BREVIK MISSION COMMUNITY HEALTH CLINIC

2003 CODE AND CONDITION SURVEY

March 1, 2004

**BREVIG MISSION
COMMUNITY HEALTH CLINIC
2003 CODE AND CONDITON SURVEY REPORT**

Existing Facility Floor Plan

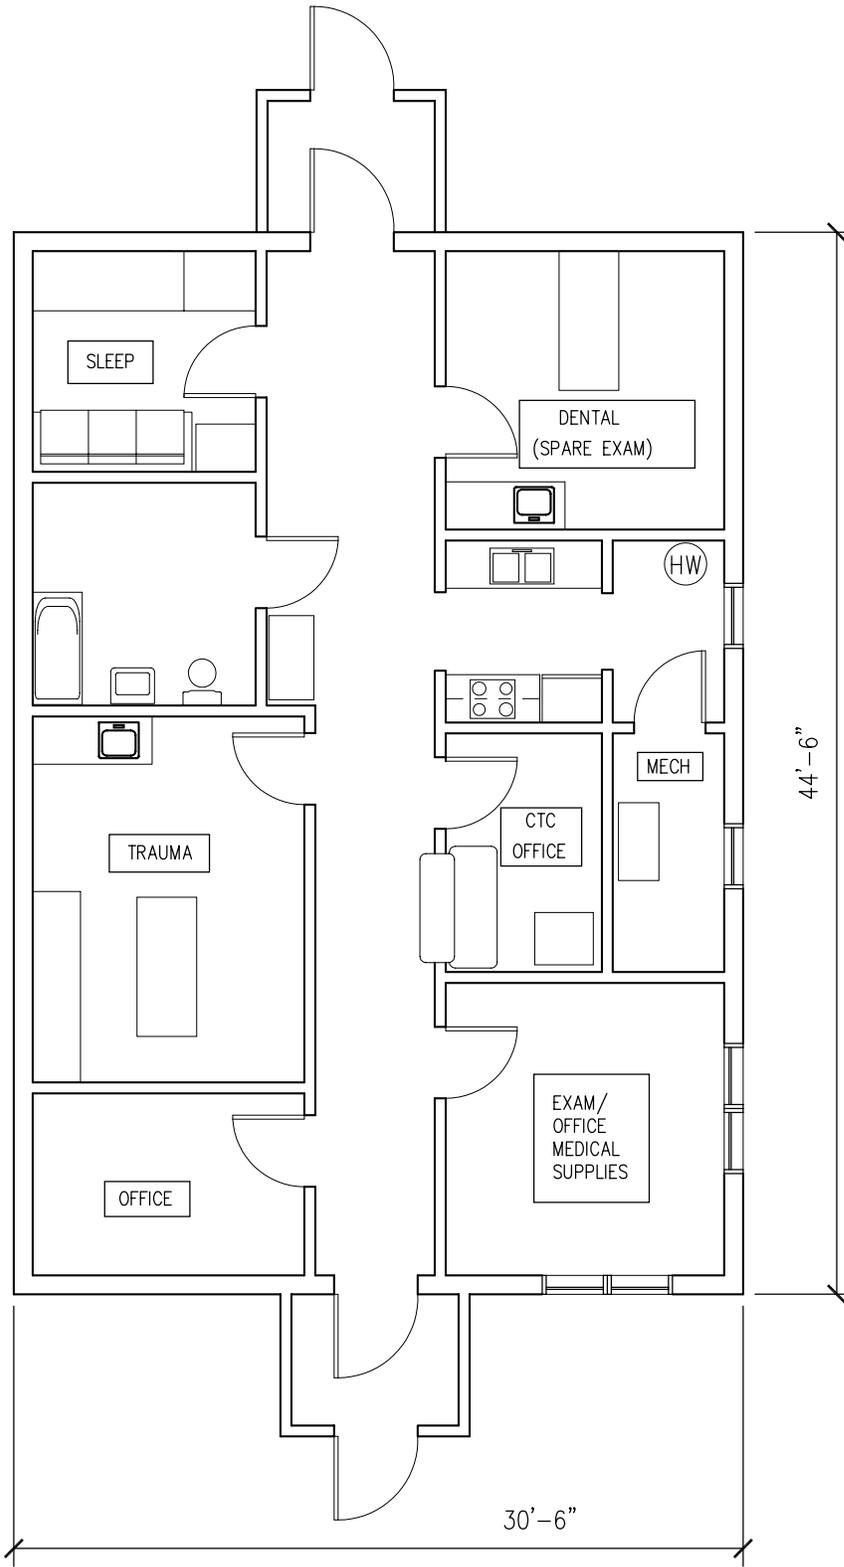
Office space limited for CHA's and travel clerk. Front exam taken up with supplies. No waiting room. The trauma room is the main exam room. There is not a separate lab or pharmacy area. Patient confidentiality is limited. Refer to floor Plan.

No realistic plan to improve clinic layout. It needs to be replaced with a larger building. This estimate item is to replace all interior furnishings and casework with new medical modular equipment.

Description: **Lack of Ventilation in the Clinic**

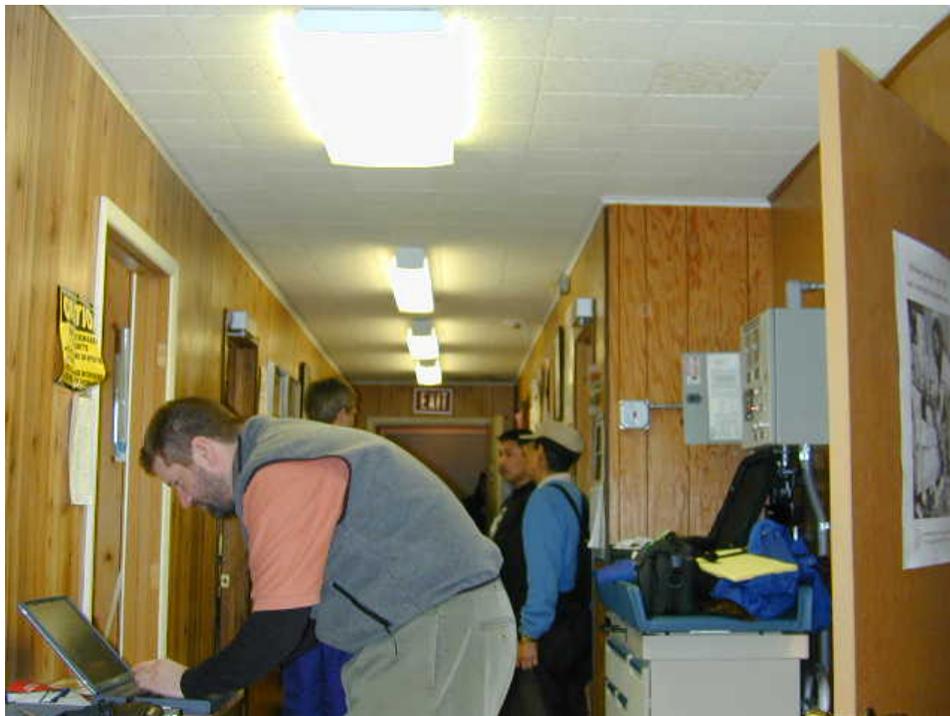
The office, exam room and dental exam room do not have an operable window nor is there any operable ventilation system in the clinic to provide ventilation air to these spaces as required by code (UBC section 1202.2.1).

Repair the existing oil-fired furnace to provide the code required ventilation for this facility. Reuse all existing ductwork and room diffusers. A new 6"Ø duct with a manual volume damper will be required to provide outside air to the furnace system.

Description: **Exhaust Air in Bathroom and Janitor's Room**

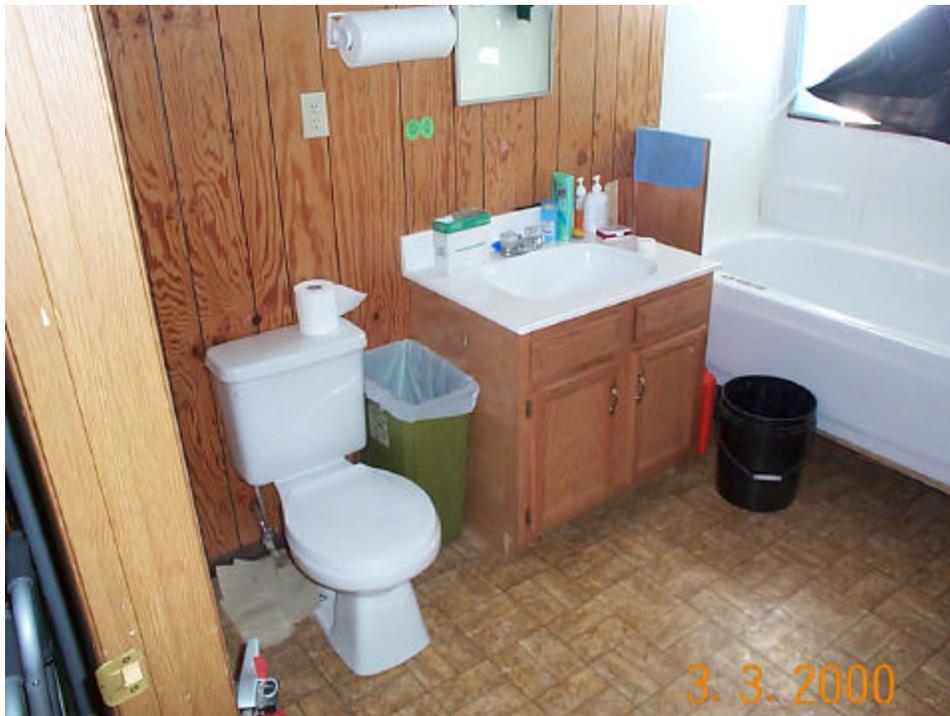
The is no exhaust air for the bathroom and janitor's room as required by code (UMC section 504 and UBC 1202.2).

Provide two ceiling mounted exhaust fan rated at 75 cfm and 0.15" s.p. Connect a 6"Ø duct and route to a roof cap and backdraft damper for each exhaust fan.
